Class II change apply for WRT54G V.2
(From WRT54GV.2 **FCC ID: Q87-WRT54GV2**)

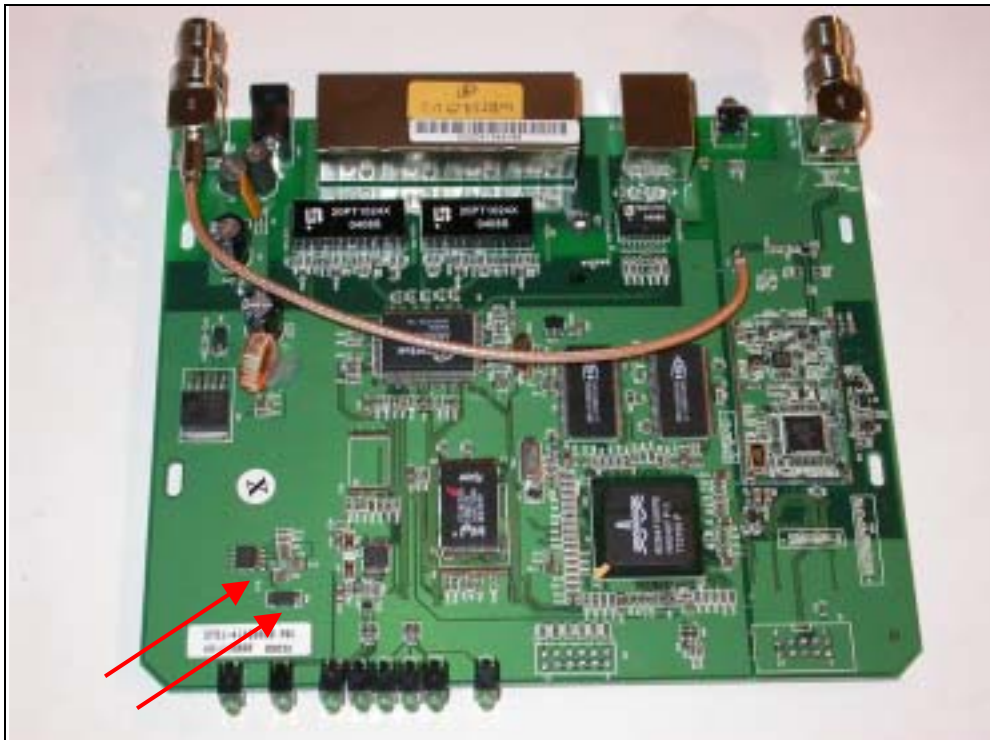
The Add Power Delay Function

AFTER (new)

BEFORE(old)
